拉合尔供水与污水处理项目（LWWMP）
AIIB 项目编号 P000074 合同编号 0074-PAK-01

第三版澄清文件

拉合尔供水与污水处理项目（LWWMP）——从LARECH COLONY至GULSHAN-E-RAVI的拉合尔污水系统

投标人疑问的第三版澄清文件

ODOR CONTROL SYSTEM (SINGLE LINE DIAGRAM) TYPICAL

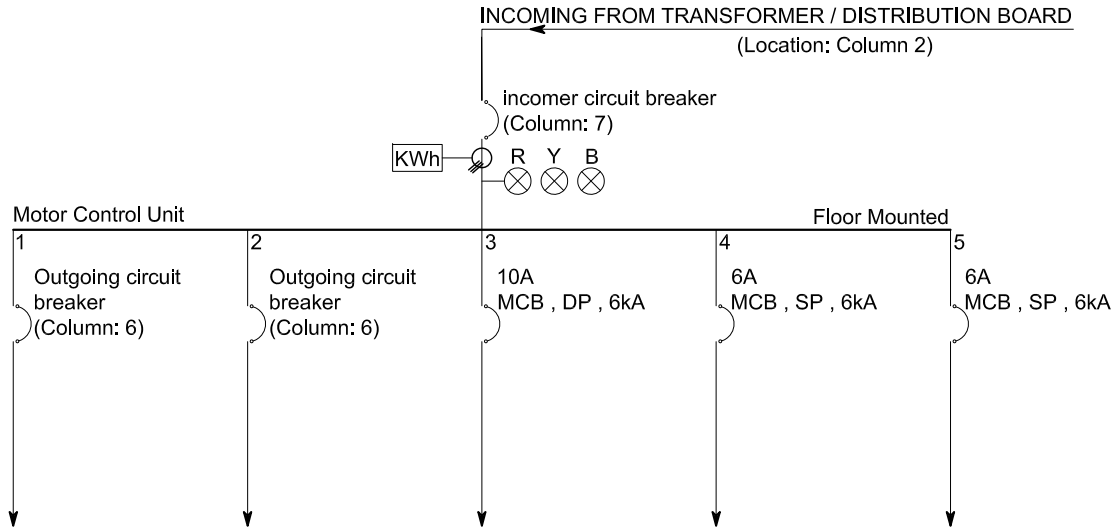
Sr #	Reference Section	Description	Employer's Response
1.	Volume 1, Part I, Section 4, Tender Forms Page 4-46-4-62 Schedule No. 5: Electrical Works	Electrical works in 23 Intermittent Pumping Stations Electrical works along sewer lines (15 Nos. Control System at Drop Structures) & 15 Nos. Control Points on Manholes along Lines and Laterals preferably at drop structures in accordance with ER Sub Clause 4.1 & 5.15 Nos. (minimum) Control Points on Manholes along Lines and Laterals ULTIMATE DISPOSAL STATION AT GULSHAN E RAVI (ELECTRICAL WORKS FOR PUMPING STATION AND ALL BUILDINGS REFERRED IN EMPLOYER'S REQUIREMENTS The Tenderer notes that only the Single Line Diagram (SLD) for the Disposal Station has been provided. The Tenderer respectfully requests the Employer to provide the load list, SLDs, layout drawings, and any additional electrical drawings for other stations, if available.	It is to clarify that EPC Contractor is responsible for detailed design of loads and SLDs for all the stations, however, the load requirement for all 23 intermittent pumping stations and typical SLDs for odor control system, ventilation system and screening system is attached as Annex-A for guidance only.

ULTIMATE DISPOSAL STATION MASTER LAYOUT PLAN PUMP HOUSE		
DATE:-	NOVEMBER, 2025	DRAWING NO.:-
		LW - TD - 402

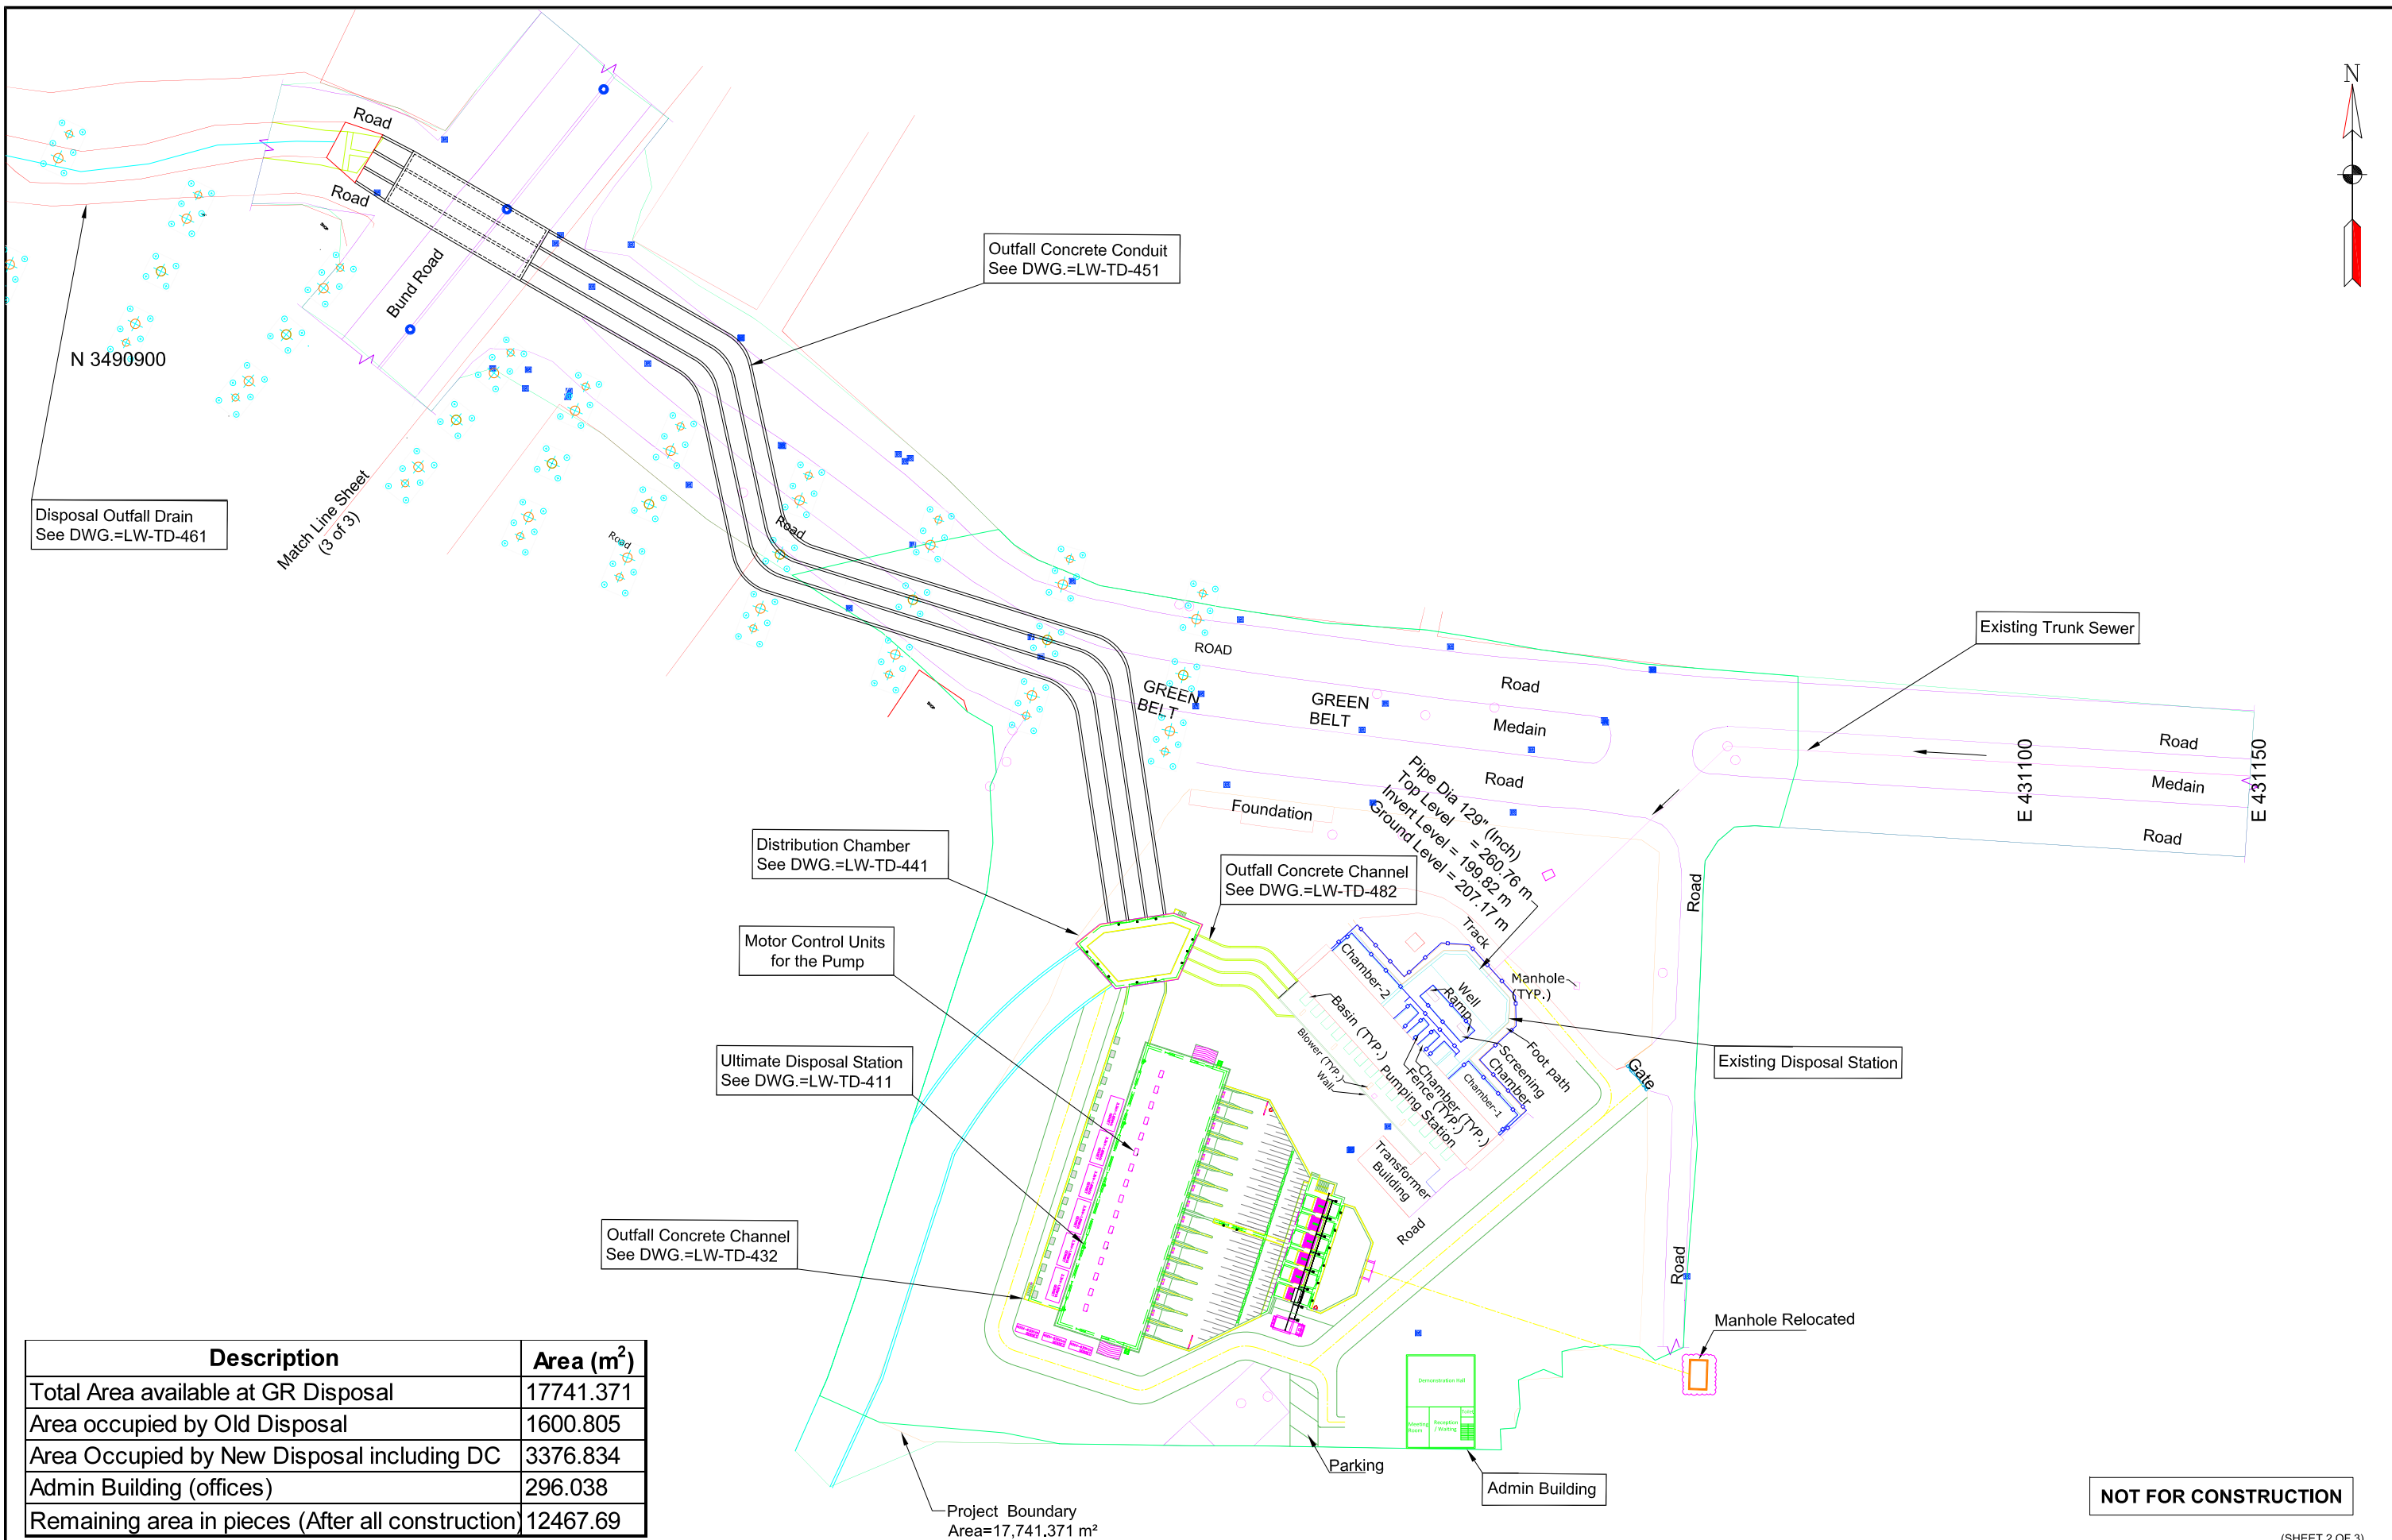
2.	Volume 2 Part II, Section 6, Employer's Requirements	It is recommended that the panel rooms can be adjusted in the dry well chamber. Can this alternate arrangement be acceptable to the Employer.	Kindly refer to response at Sr. No. 39 of the Clarifications and Minutes of Meeting of 1st Pre-Tender Meeting, wherein, the updated drawing # LW-TD-411 shall prevail, however, as an alternative arrangement, the panel rooms can be adjusted in the dry well chamber as per Annex-B.

供水与环境卫生 拉合尔供水与环境卫生机构	    A Joint Venture	版本				控制	绘制		WASA 所有土地		比例尺	
			03				校核人					
			02				建议					
			01				CHD./VER.		日期: —	图纸编号	W-TD-005A	版本号: —
			说明	日期	批准		版本号	2025年12月

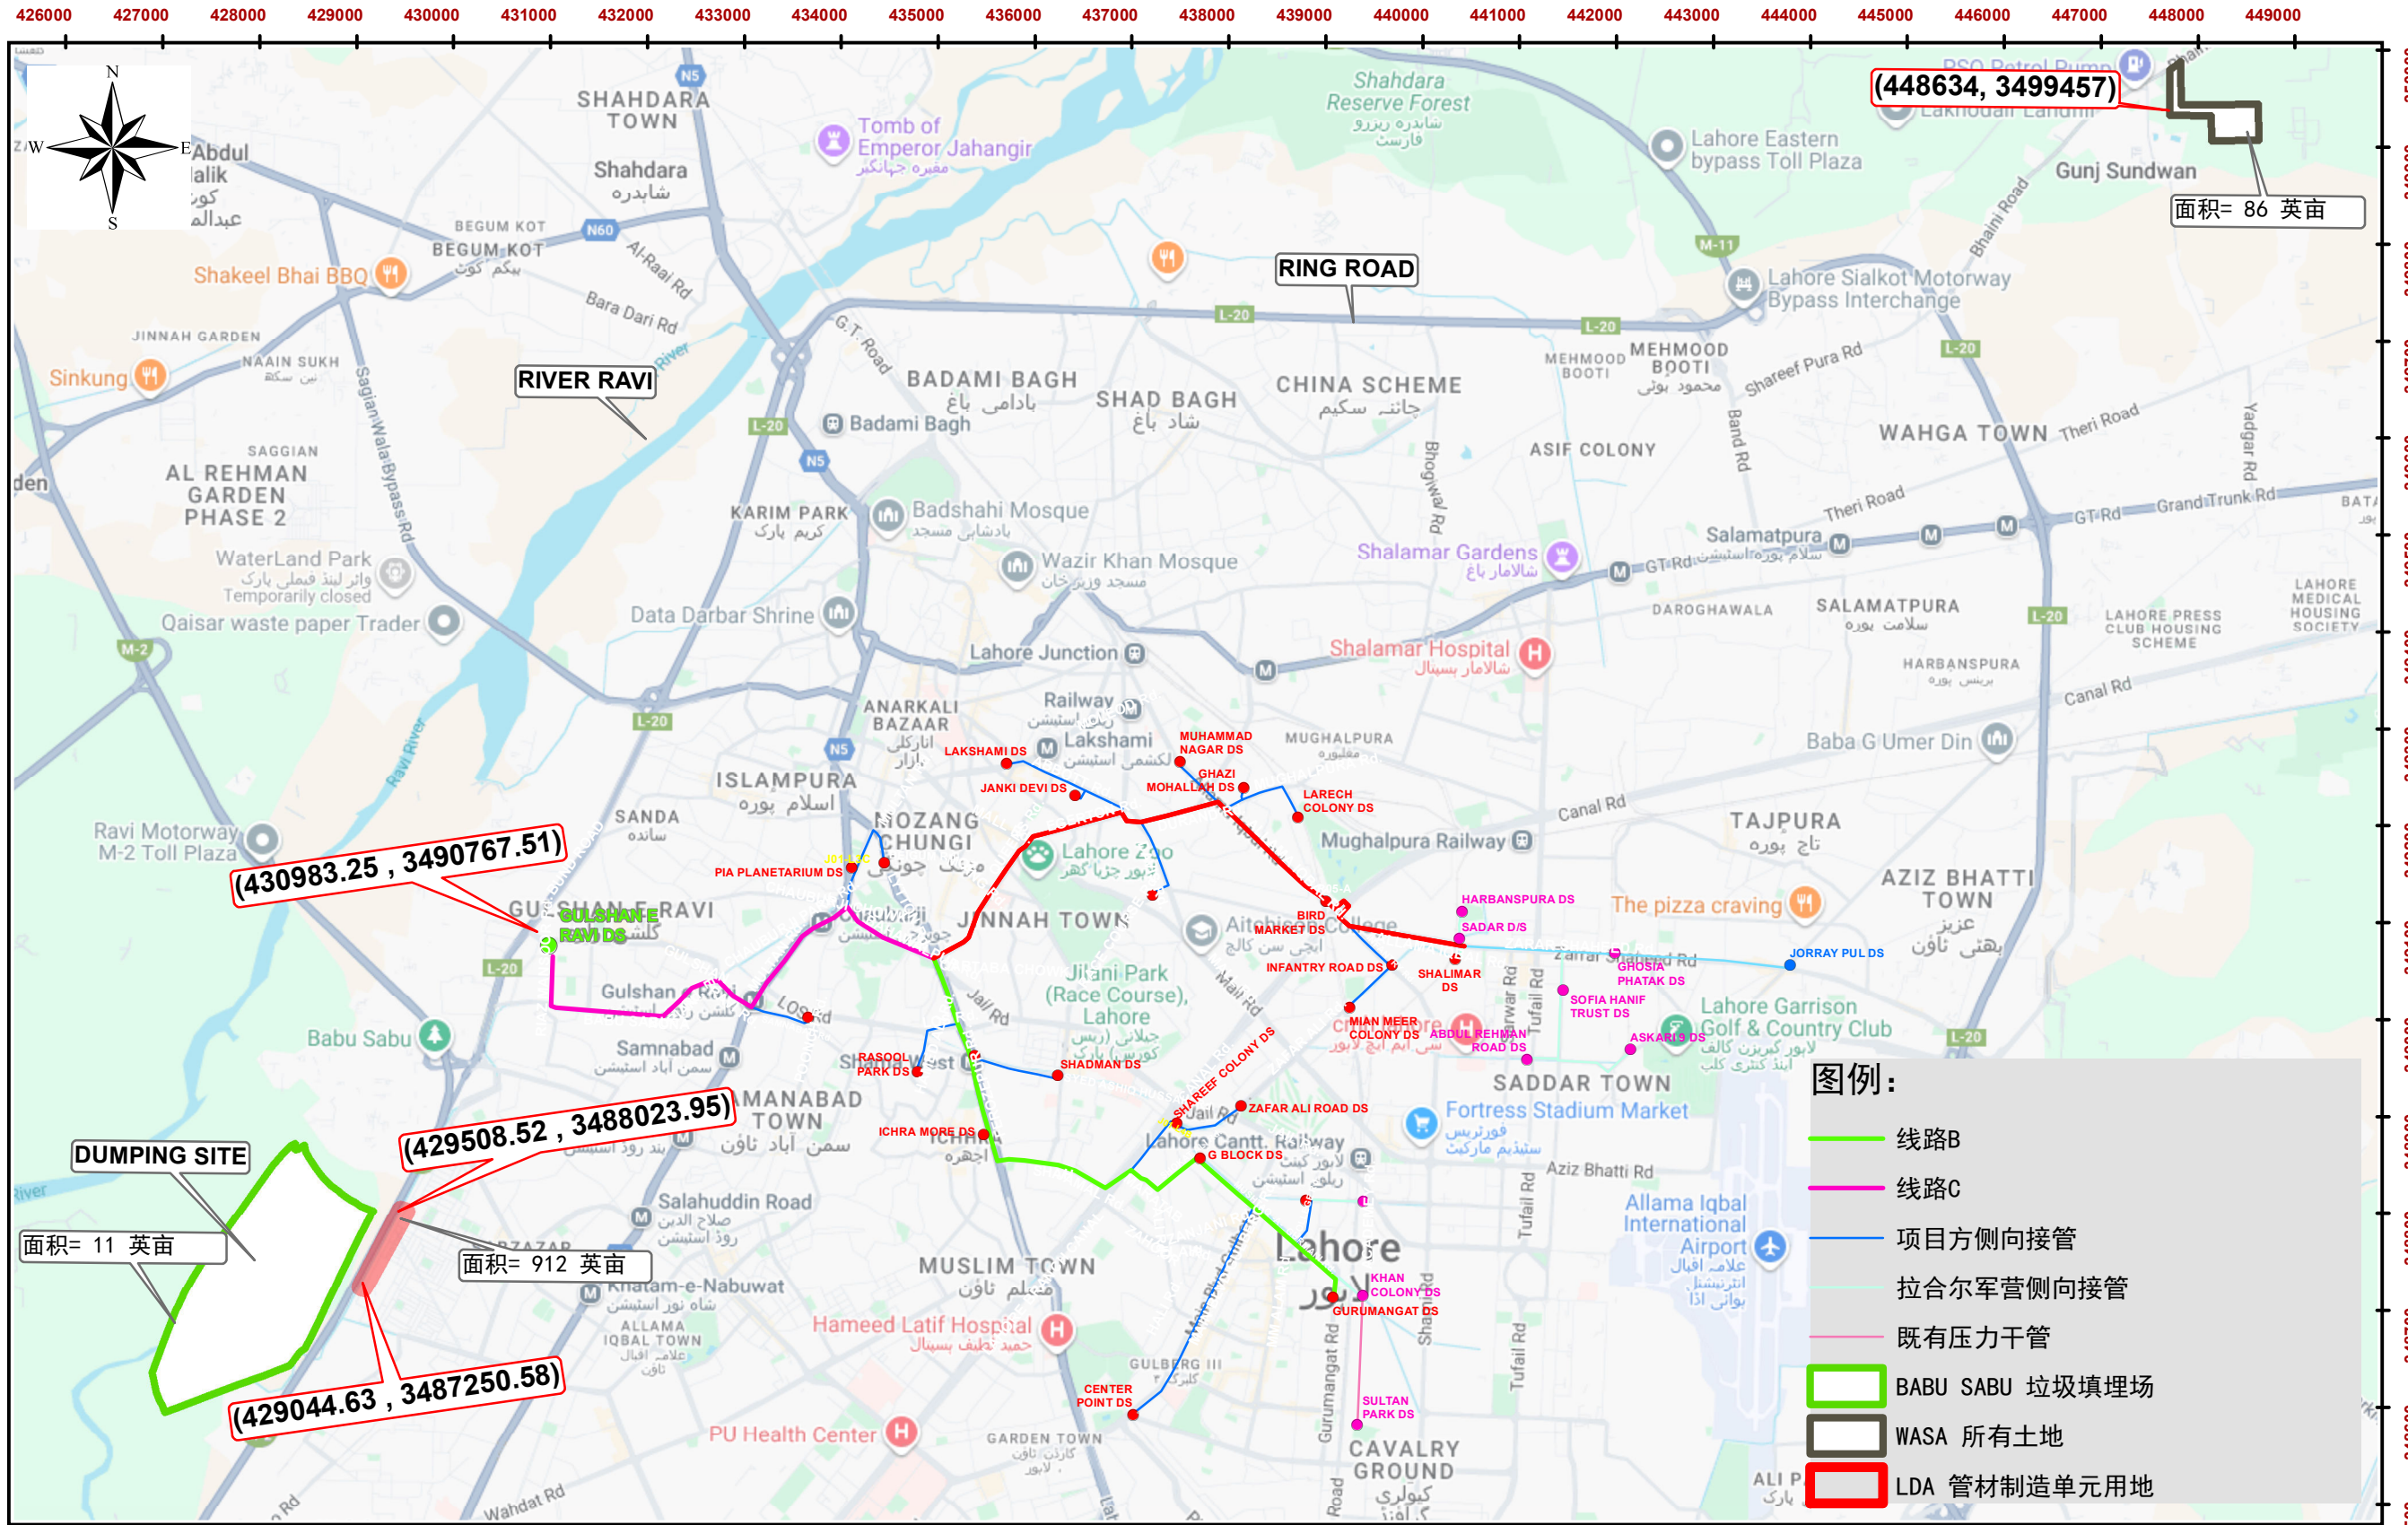
17.	Volume 2, Part II, Section 6, Employer's Requirement	During the site visit, the Tenderer has identified an additional parcel of land probably owned by Lahore Development Authority (LDA), located in proximity to the Project area and WASA owned land, which appears suitable for use as a pipe manufacturing and casting yard. In this regard, the Tenderer seeks clarification	It is to clarify that in addition to the sites identified in the Tender Documents, the Contractor may utilize any other suitable land, including the land owned by Lahore Development Authority (LDA) identified during the site visit, for pipe manufacturing and associated activities, subject to obtaining all requisite approvals and NOCs from the relevant authorities. In this regard, the updated

Sr #	Reference Section	Description	Employer's Response
		whether, subject to obtaining all requisite approvals and permissions from the relevant authorities, the said land may also be utilized for pipe manufacturing, storage, and associated construction activities under the Contract.	drawing for sites that can be used by the Contractor are attached as Annex-D.
